AGENDA

AGENDA ITEM: Discussion and action to make a recommendation to the Village Board regarding Ordinance 2025-07, an ordinance rezoning parcel #0610-024-9691-1 from A-1 Agricultural Transition to PD - Planned Development District - General Plan Approved. Rezoning requested by Lakestone Properties.

Since the May 20, 2025 Plan Commission public hearings, the applicant team has completed the following updates. It should be noted that some of the details within the Village Engineer and Fire Chief's letters are to be included in the future Final Plat and Detailed Plan.

SPERLE CORNERS – VILLAGE OF MCFARLAND
GENERAL DEVELOPMENT PLAN
EXHIBIT: 1 OF 1
DATED: JUNE 6, 2025

SHEET: C-17

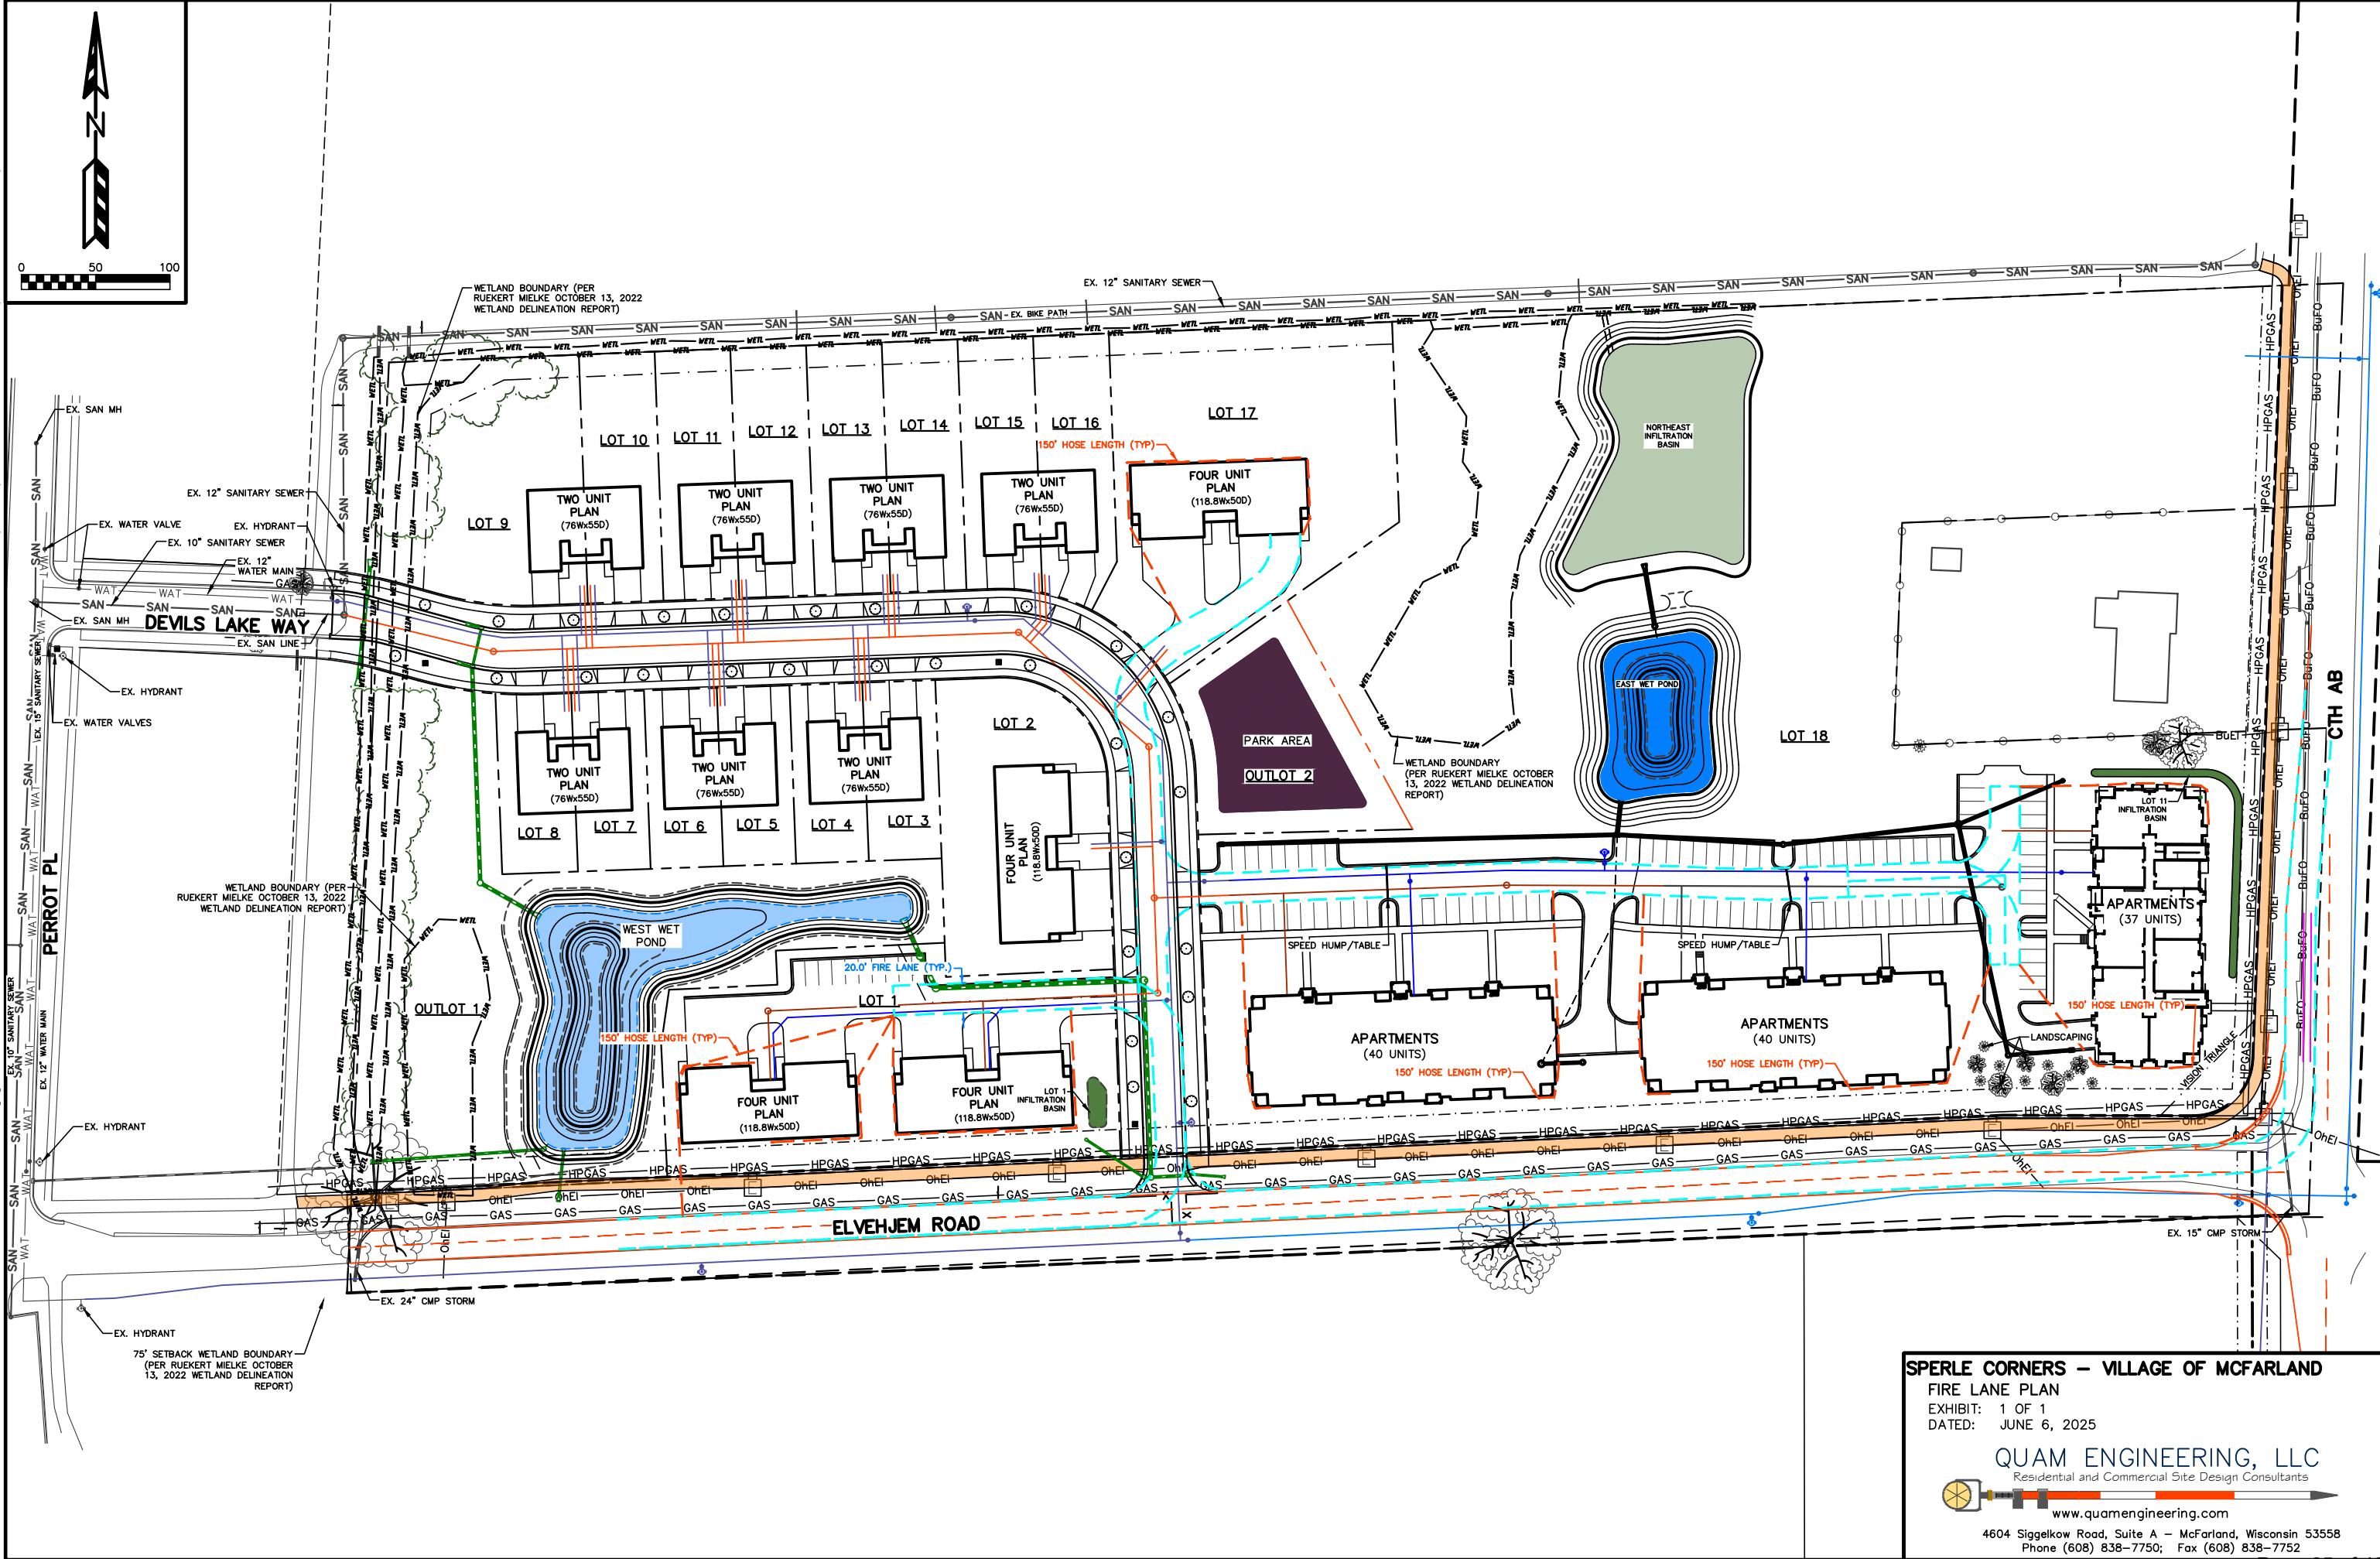
- Sheet 16 of 17 from the plan set dated 4/8/2025 indicates a typical roadway cross-section of 32' F-F (inclusive of curb) and plans show 24' roadway exclusive of curb and 28' F-F (inclusive of curb). 24' roadways would eliminate on street parking. Note aerial fire apparatus roads (buildings exceeding 30' in height) or within 20' of a fire hydrant location require 26' roadway exclusive of curbs. The engineer's response is indicating that the roadway will be reduced to 24' exclusive of curbs, which will restrict street parking.

- Sheet 16 of 17 indicates a typical roadway cross-section of 32' F-F (inclusive of curb) and plans show 24' roadway exclusive of curb. 24' roadways would eliminate on street parking. Note aerial fire apparatus roads (buildings exceeding 30' in height) or within 20' of a fire hydrant location require 26' roadway exclusive of curbs. **30' tall buildings along Devils Lake Way are not anticipated. The typical roadway cross section on sheet 16 has been modified to indicate 28' face of curb to face of curb dimension.**
